PROJECT NAME: FERRISBURGH/VERGS-FERRISBURGH
 PROJECT NUMBER: CMG PARK (15)S/STP EHO(21)

FILE NAME: ...Highway\PlotFiles\50water.plot PLOT DATE: 5/9/2006
 PROJECT LEADER: WLD DRAWN BY: JSK
 DESIGNED BY: BFR CHECKED BY: JTM
WATER LINE PLAN SHEET 50 OF 65

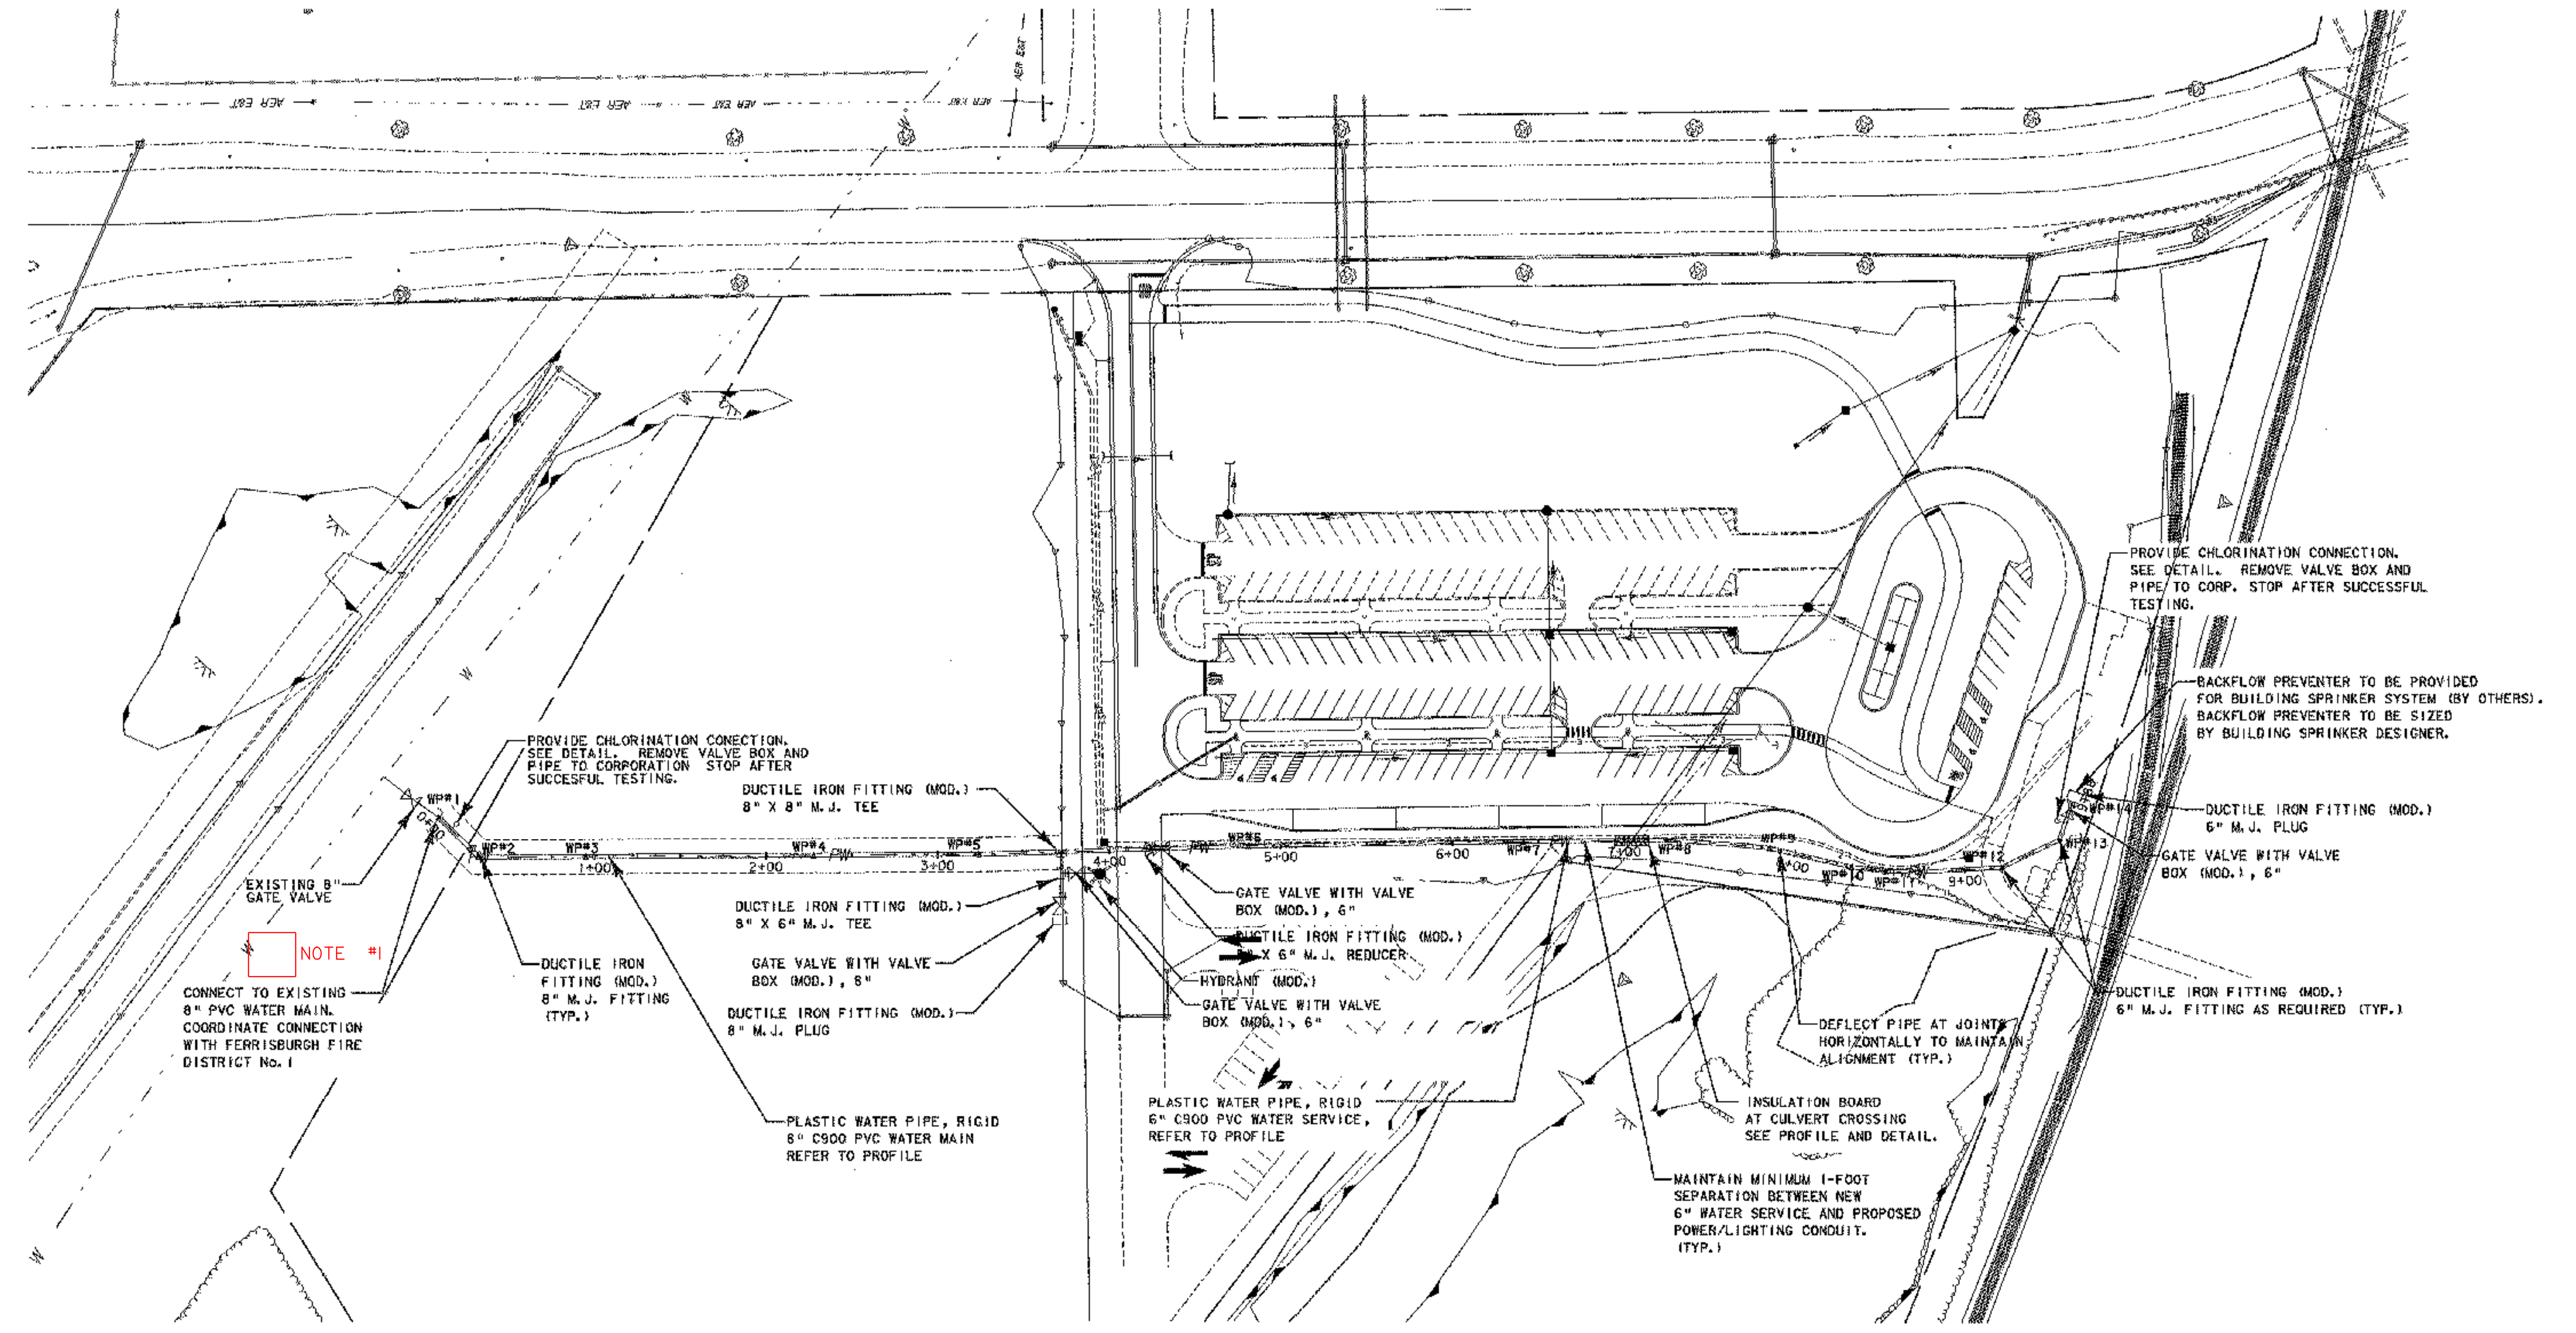
NOTE #1: UNABLE TO LOCATE ALLEGED STUB AS DRAWN. STANTEC PROVIDED ADD'L INFO ON 10/23/06 TO LOOK 158.2FT TO THE NORTH OF DESIGN LOCATION. AT THAT APPROX. LOCATION THERE SEEMS TO BE AN AIR BLOW OFF. DRN 10/24/06
